# THE RUGER® M77 RIFLE

## PRODUCT SAFETY WARNING AND RECALL NOTICE

Figure 1

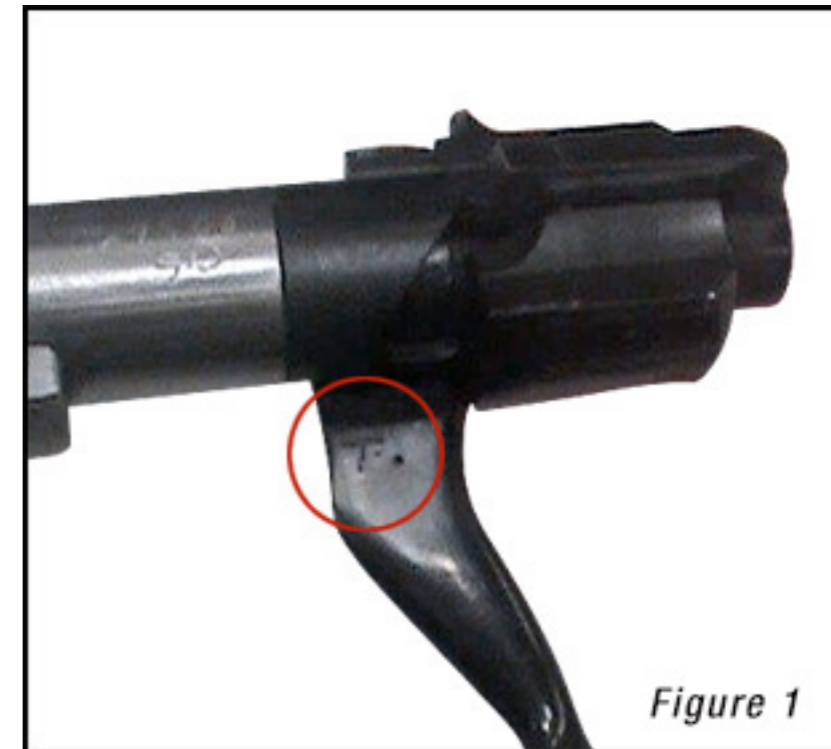
Ruger® M77® bolt action rifles produced in later years have the set screw permanently secured. These rifles have a "T" inscribed on the underside of the bolt handle (see Figure 1). For your safety, we ask that all owners of the M77® rifles (except those with a "T" underneath the bolt handle) contact us for a new locking screw to replace your present overtravel adjustments set screw.

**Step 2** - We will verify that your rifle is eligible for the new set screw, and if so, will send you a new locking screw that will replace your present overtravel adjustments set screw and detailed instructions for quick, easy installation. There is no charge for this service and replacing the screw will have no adverse effect on trigger pull.
